George M. Hornberger

18 April, 1995

Main points.

GENERAL COMMENTS

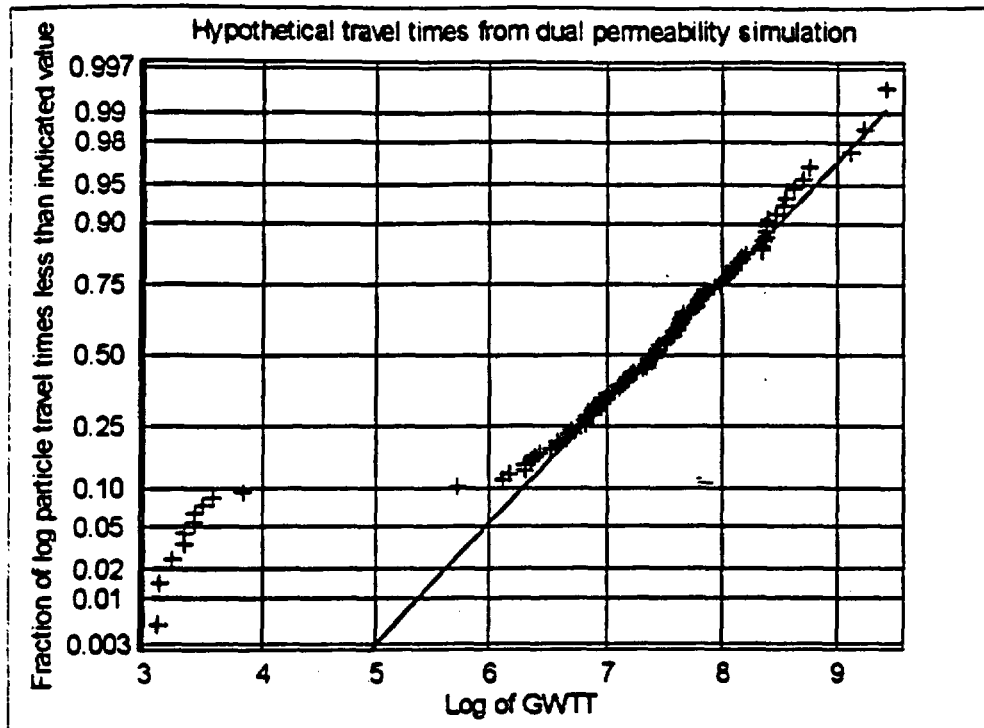
I interpreted something that Jeff Pohle said at the meeting to be eminently sensible. (Of course, I'm not certain that my interpretation of what Jeff said is correct, but). My take on it is the following. The flow paths at Yucca Mountain are likely to fall into two categories: "fast" and "slow". The slow paths are all those for which a significant part of the flow occurs in the matrix. The fast paths are those for which a good part of the flow occurs through fractures. Barnard's presentation of (hypothetical) calculational results at the meeting illustrate this. Essentially, he had the "slow" particles with a GWTT of 6×10^6 years and the "fast" particles having times lognormally distributed across 10^3 - 10^4 years. If we consider the "slow" times to be distributed across 5×10^3 - 5×10^6 years, Barnard's probability plot (assuming 100 particles with 10 in the "fast" path and 90 in the "slow" path) would look something like the graph on the following page.

The essential point is that all of the "fast" GWTT's are "the same"; that is, the fast times are all much larger than the bulk of the times. This is the critical point that (I think) Jeff was making. [Note that the scale that I use stretches the "slow" times out to what they should be. This explicit recognition that the "slow" times are indeed very slow (and variable) helps illustrate (I think) that the fast times are all equivalent; Raleigh plotted all of the "slow" times at 6×10^6 years so the "fast" times showed up as much more variable than the others when just the reverse is true.] Taking all of the fast GWTT's to be equivalent leads naturally to an interpretation of the GWTT requirement that the median (say) of all of the fast paths be less than 1000 years. This seems to me to be a sensible interpretation, to a large extent avoiding the problems of looking at the extremes of the distribution.

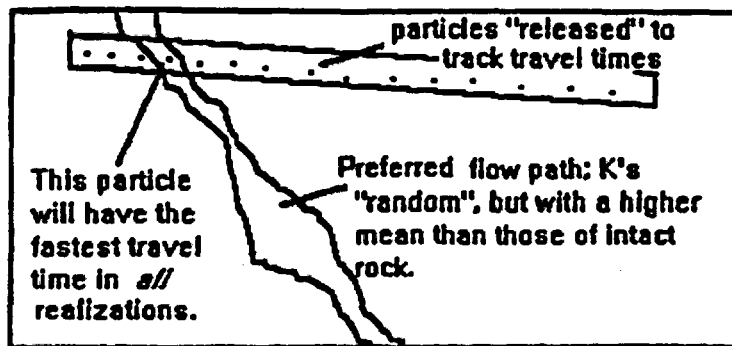
Having tentatively adopted the above interpretation, I must admit that there are some lingering concerns. First, suppose that the GWTT's for Yucca Mountain do not segregate into two classes. How can we identify the "fast" paths? In this case, Jeff's idea would not be easy to implement unambiguously. Perhaps the fastest 10% of the particle travel times could be used. This case would need more thought. Second, the travel-time distribution for a single realization (a single run of the model with a fixed set of parameter values) is not equivalent to a sample from some probability distribution; that is, the spatial distribution of conductivities is not random so the position from which a particle is released will have a deterministic component to its calculated travel time. For example, suppose a fault zone cut through the repository as shown schematically below.

Hydraulic parameters for any realization would be chosen from probability distributions (conditional on position) and GWTT's for each particle would vary from one realization to the next. The fastest path in *any* realization, however, would always be through the fracture zone. In this case, one could argue that the NRC regulation should be interpreted as pertaining to the absolute fastest travel time. I would modify this argument, however, that DOE should circumvent this case with judicious engineering. Once the repository is constructed, fault zones can be identified and emplacement of waste in these zones can be avoided. In this way, such fault zones (or other preferred flow paths) are not "credible" paths for transport of nuclides. Nevertheless, NRC needs to be able to evaluate the fastest paths from a sequence of realizations, even though these values -- in and of themselves -- will not form the basis for the GWTT regulation.
